From: Griffin, Tim
Sent: 13 October 2022 16:12
To: Altman, Rebecca
Cc: Ellison, Mark
Subject: Re: DC/22/93827 Land at Villeneuve St George Way, Eastleigh - landscape comments

I have been asked to provide landscape comments on this discharge of conditions application.

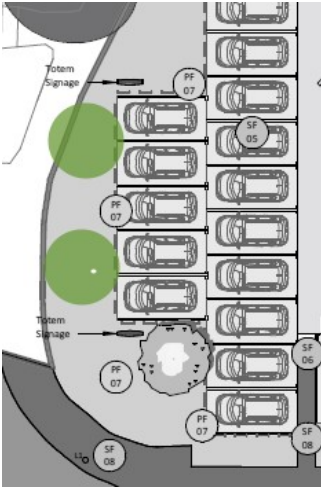
At this stage, I am looking for assurances that all the tree planting indicated on the landscape plans will be deliverable. In particular, please ask the applicant to confirm that the existing drainage and proposed lighting columns will not lead to any omissions of new trees along Villeneuve Way.

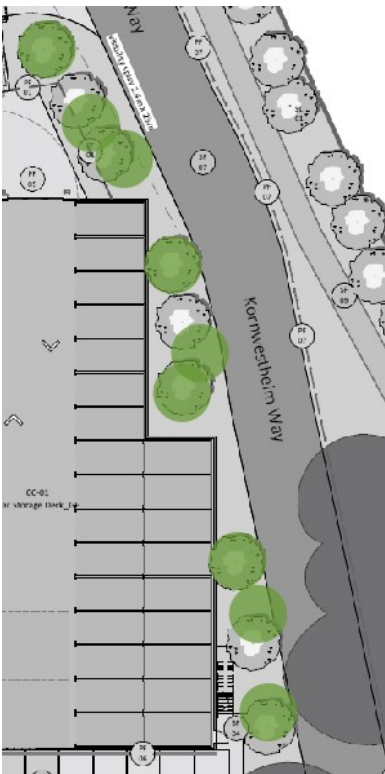
c/ It is disappointing that my earlier comment regarding additional tree planting along the Leigh Road frontage has not yet been accommodated. I can see no good reason why 2 further trees cannot be planted between the totem signs (see extract below). I understand that Hendy may wish for maximum visibility of their new facility, however, this development is at a scale that cannot be missed.

The more easterly totem sign seems excessive, especially as it will be partly hidden behind the existing trees along Leigh Road. Perhaps a single totem sign is sufficient.

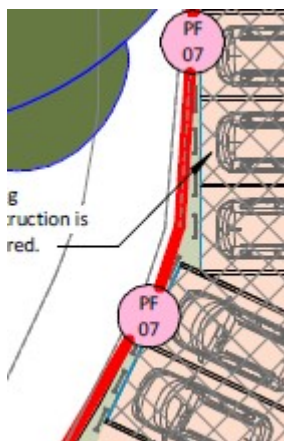
d/ The tree planting along the rear to screen the parking deck is intended to have a more naturalistic feel. Please adjust the tree positions as below for an informal effect.

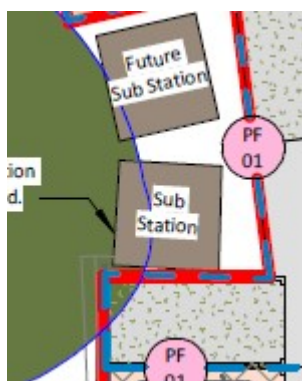
g/ Any thin strips of soft landscape (such as areas below) are too narrow for planting. Please replace with suitable hard landscape alternative.

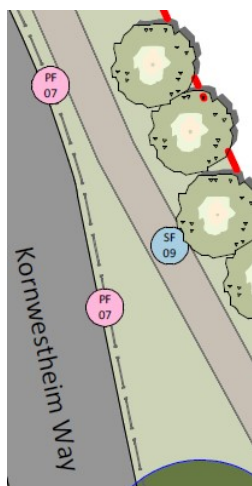
h/ Is there scope to omit this space adjacent the sub stn. and replace with screen planting? It will be a very tight space to access and inaccessible when the gates are open.

Sub. stns. are intrusive in views, so planting here would be welcomed.

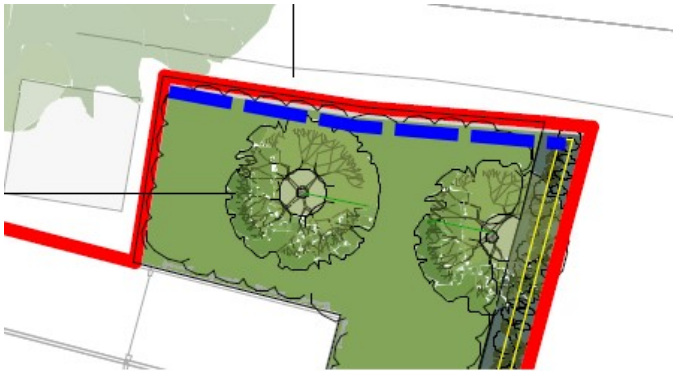
j/ I note a hooped perimeter barrier PF07 is proposed along the length of the Gateway footpath.

I need to check with Mark, but my own view would be that this is not the best detail here as it implies this area is part of Hendy Fords site, rather than reflecting the character of the adjacent Fleming Park. I would have thought a steel post, or a bespoke knee rail detail, would be more appropriate here (steel for longevity). A series of posts would be less visually intrusive. I think there is a low earth berm along this edge at the moment.

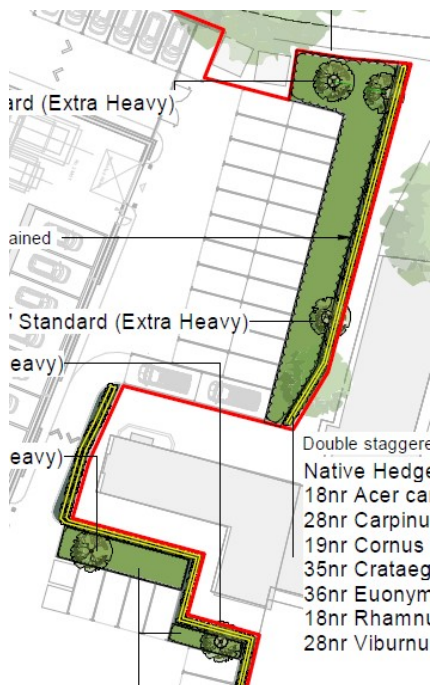
h/ Suggest this area of planting around the proposed focal point should be different from adjacent planting to highlight area as feature. Please review once the type of focal point has been agreed.

Tree Pits Details

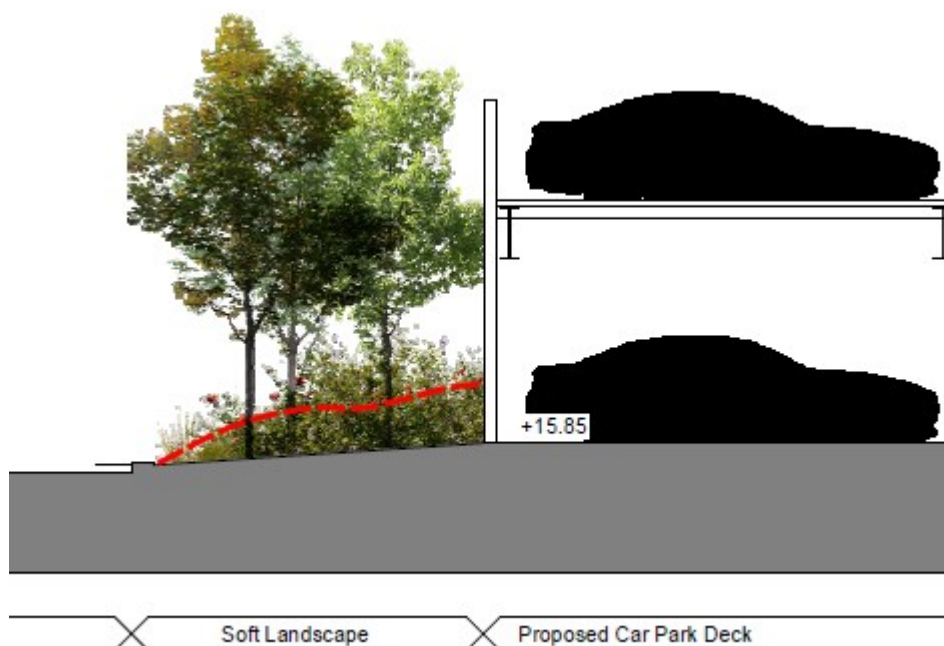
a/ Check labelling on tree pit sections - labels missing include topsoil layer, bark mulch, staking, irrigation pipes etc. Are any ameliorants/fertiliser being added to the topsoil backfill? Irrigation pipes to be placed around the **edge of the pit** not the edge of the rootball.
